From: Jonathan Talley <jon@jtalimited.co.uk>
Sent: 13 January 2025 11:25:19 UTC+00:00
To: "drainage" <drainage@midsussex.gov.uk>
Cc: "Anna Tidey" <anna.tidey@midsussex.gov.uk>
Subject: Re: 2025.01.13 Re: DM/24/2933 - 23 Meadow Drive Lindfield Haywards Heath West Sussex RH16 2RS

From: drainage <drainage@midsussex.gov.uk>
Sent: 20 December 2024 17:26
To: Anna Tidey <anna.tidey@midsussex.gov.uk>
Cc: drainage <drainage@midsussex.gov.uk>
Subject: 2024.12.20 Re: DM/24/2933 - App - Minor - 23 Meadow Drive Lindfield
Haywards Heath West Sussex RH16 2RS

Thank you for consulting the Flood Risk and Drainage Team with regard to the above application. We understand the application is for demolition of existing garage and erection of a two storey rear and side extension and new front porch. The Flood Risk Assessment provided by the Applicant has been reviewed, and we would comment as follows:

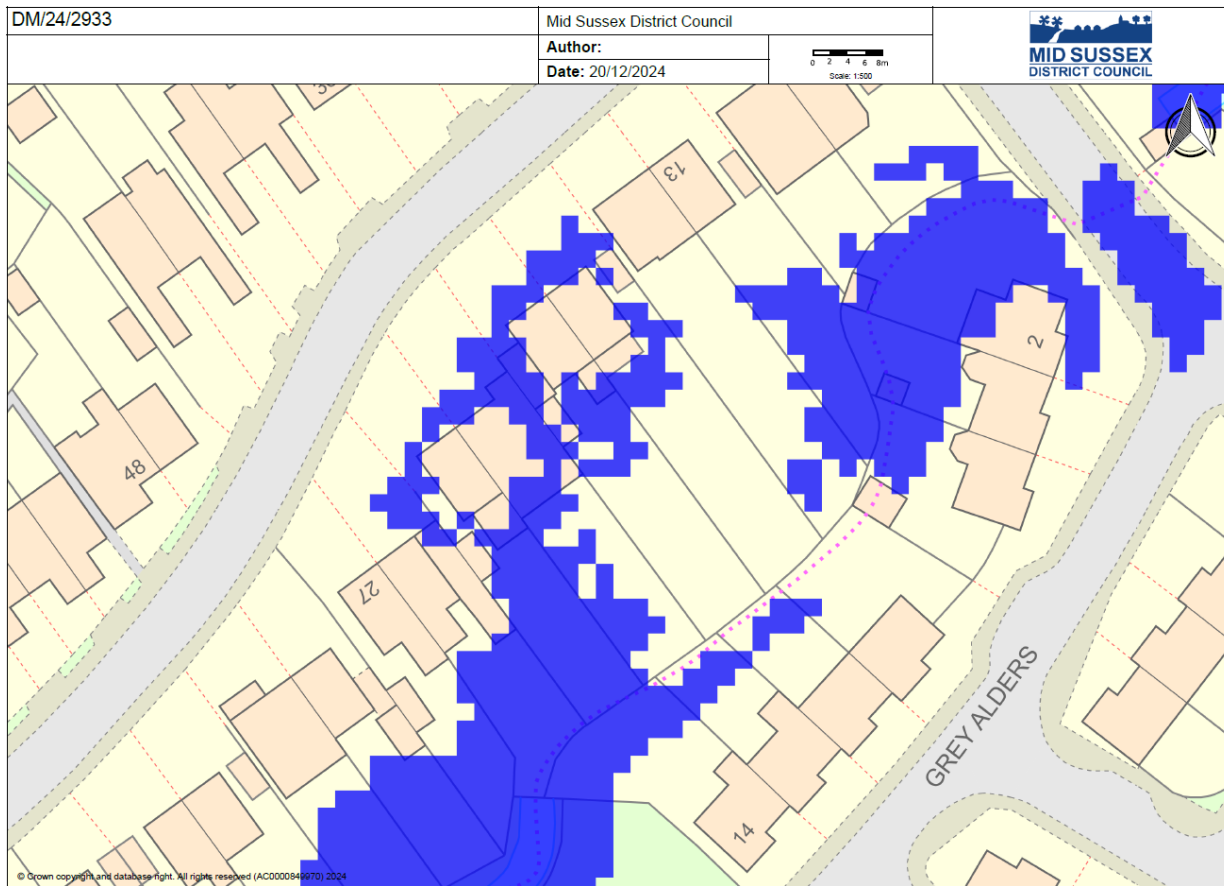
Due to the need to consider all sources of flooding consistently with river flooding, Mid Sussex District Council (in line with West Sussex Lead Local Flood Authority advice) now follow the below table when considering flood risk. The proposed development site is located within an area impacted by the 1:30, 1:100 and 1:1,000 flood events (high, medium, and low surface water flood risk). Following the approach set out under the NPPF for assessing fluvial flood risk (flood zones) this area would be considered consistent with Flood Zone 3b (1:30 extent), Flood Zone 3a (1:100 extent), and Flood Zone 2 (1:1000 extent).

Based on the latest guidance that all sources of flooding should be considered consistently the site meets one of the reasons an area would be considered functional floodplain (Flood Zone 3b); it's location within the 1:30 surface water flood extent.

It is the Flood Risk and Drainage Team’s findings that, following the latest guidance on assessing flood risk the site is located within the equivalent of Flood Zone 3b (1:30 flood extent) and the proposed development is a more vulnerable development.

As per the Environment Agency standing advice for minor extensions, development within the 1:30 flood extent is not permissible.

- In order to assist please see above extract from our Environment Agency mapping of the surface water flood extents. There is a publicly available searchable and downloadable maps available: Defra Data Services Platform (select the relevant layers for the 1:30, 1:100 and/or 1:1000 extents) Please could the Applicant overlay their proposed extension footprint on the above (or similar) screenshot of the 1:30 flood extent for us to review any encroachment?

If the proposal is outside of this extent then additional resistance and resilience mitigation will need to be evidenced at this location, as this development is classified as ‘more vulnerable’.

In addition, the Flood and Drainage Team would have no objection to the scheme if surface water modelling can be provided which demonstrates that the development design ensures that, for the 1:100 year + climate change event:

- Site users are safe in the event of a flood
- There is no loss of floodplain storage
- There is no impedance of overland flows
- There is no increase in flood risk

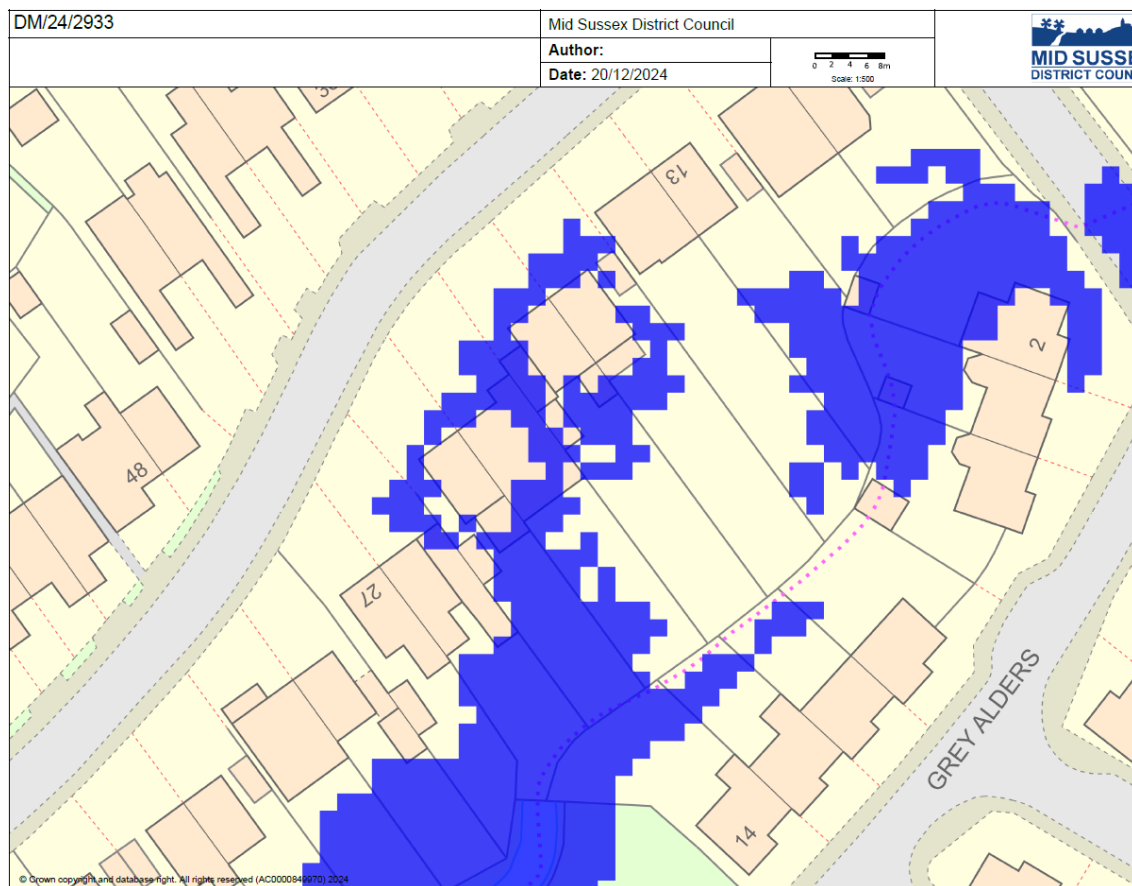
The proposed development site is located within an area impacted by the 1:30, 1:100 and 1:1,000 flood events (high, medium, and low surface water flood risk). Following the approach set out under the NPPF for assessing fluvial flood risk (flood zones) this area would be considered consistent with Flood Zone 3b (1:30 extent), Flood Zone 3a (1:100 extent), and Flood Zone 2 (1:1000 extent).

Based on the latest guidance that all sources of flooding should be considered consistently the site meets one of the reasons an area would be considered functional floodplain (Flood Zone 3b); it's location within the 1:30 surface water flood extent.

Flood Zone 3b (1:30 flood extent) and the proposed development is a more vulnerable development.

As per the Environment Agency standing advice for minor extensions, development within the 1:30 flood extent is not permissible. In the event that the proposal is outside of this extent then additional resistance and resilience mitigation will need to be evidenced at this location, as this development is classified as 'more vulnerable'

In addition, the Flood and Drainage Team would have no objection to the scheme if surface water modelling can be provided which demonstrates that the development design ensures that, for the 1:100 year + climate change event:

- Site users are safe in the event of a flood
- There is no loss of floodplain storage
- There is no impedance of overland flows
- There is no increase in flood risk
